APPLIES TO: This service bulletin applies to Emergency Response chassis cabs identified in the table below.

CONDITION: The compartment door switch may become inoperative.

CORRECTION: Relocate compartment door switch.

FIG. 3-1

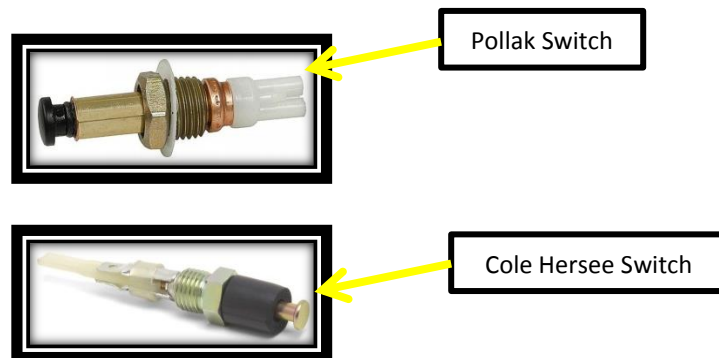
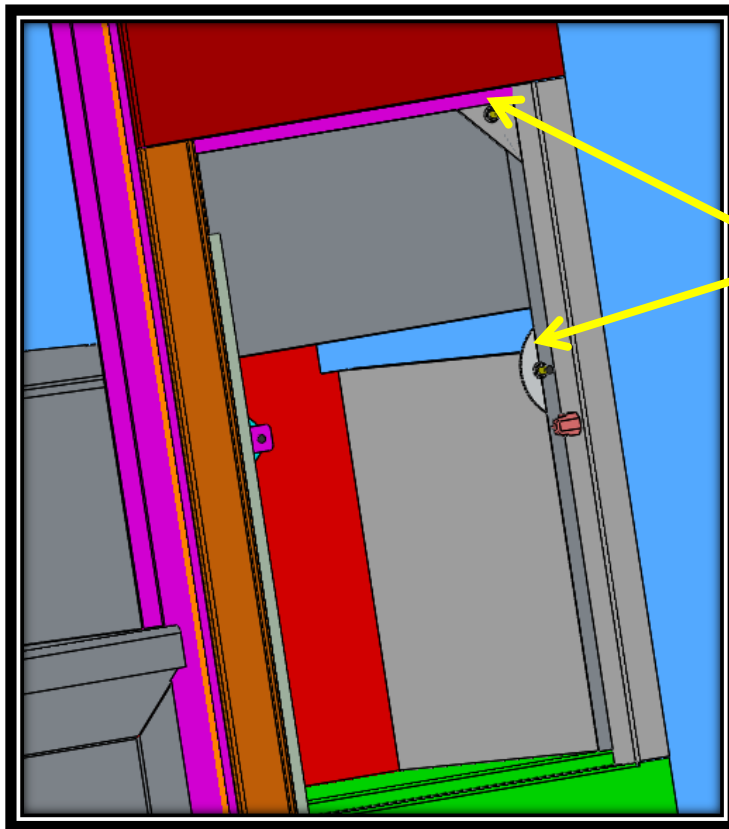
1. Identify which compartment door switch is installed (either Pollak or Cole Hersee). Kit S-2623-001 is required for the Pollak switch and kit S-2623-002 is required for the Cole Hersee switch. Refer to FIG. 3-1 for switch identification.

FIG. 5-1

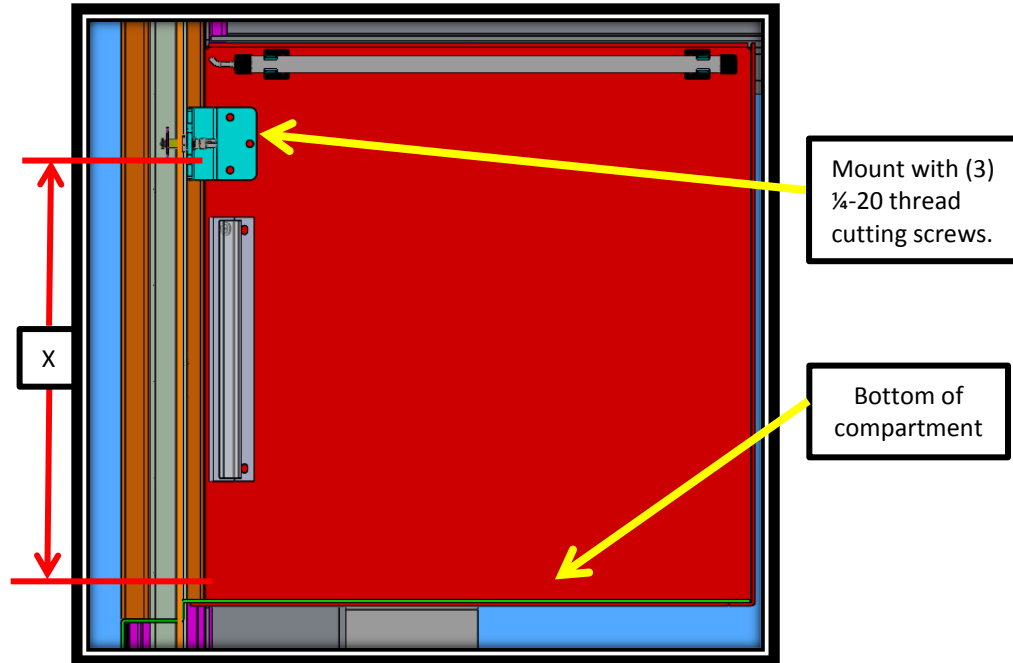
3. Install new switch bracket on the hinge side of the compartment with vertical placement (dimension "X") in a best fit location for compartment options. The outboard face of the bracket should be 0.25" from the outboard face of the bulb seal flange. Refer to FIG. 5-1 and FIG. 5-2.

FIG. 6-1

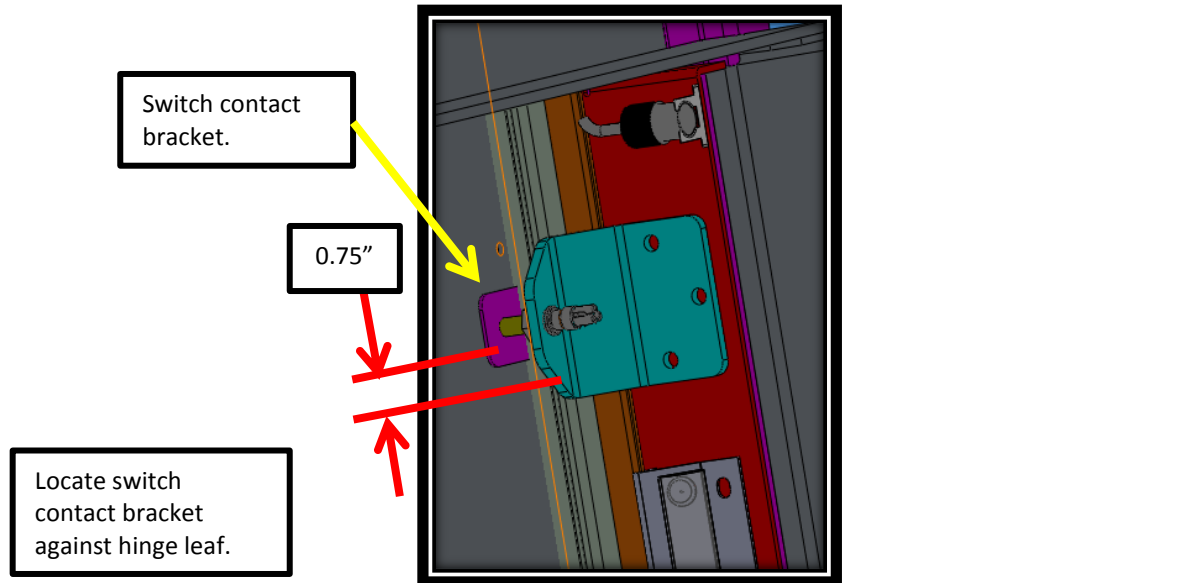
4. Install the door switch contact bracket on the interior surface of the compartment door using urethane adhesive Sika Tack Ultrafast US or equivalent. Clean and prime the surfaces per the adhesive manufacturers recommendations. This bracket should be centered vertically with the switch bracket at 0.75" from the bottom of the switch bracket. Refer to FIG. 6-1, 6-2.

FIG. 7-1

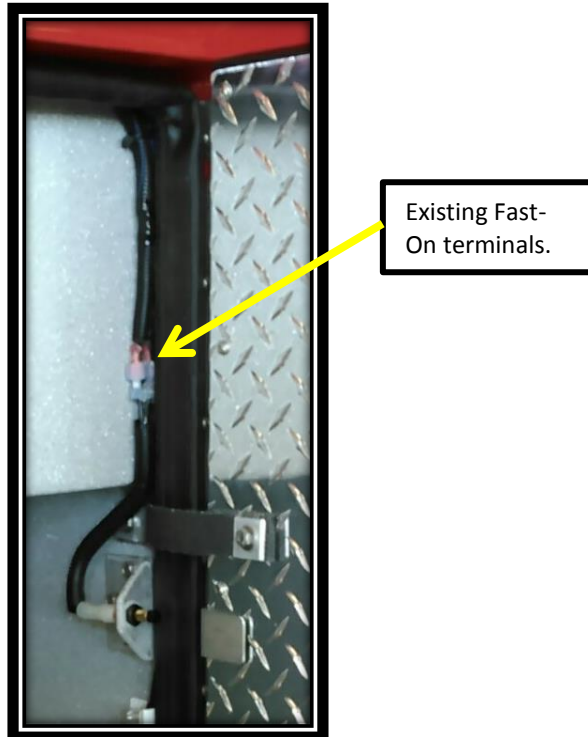
7. Re-route the existing door switch wires from the latch side to the hinge side of the door frame and re-connect the existing wires to the new door switch. The existing fast-on terminals can be removed and the wires can be spliced together with solder and heatshrink to reduce the wire bundle size if desired. Depending on the number of compartment lights, the installation can be further reduced by using a single piece of 1/2" loom to route both switch and light wiring together. Refer to FIG. 7-1 and FIG. 8-1.
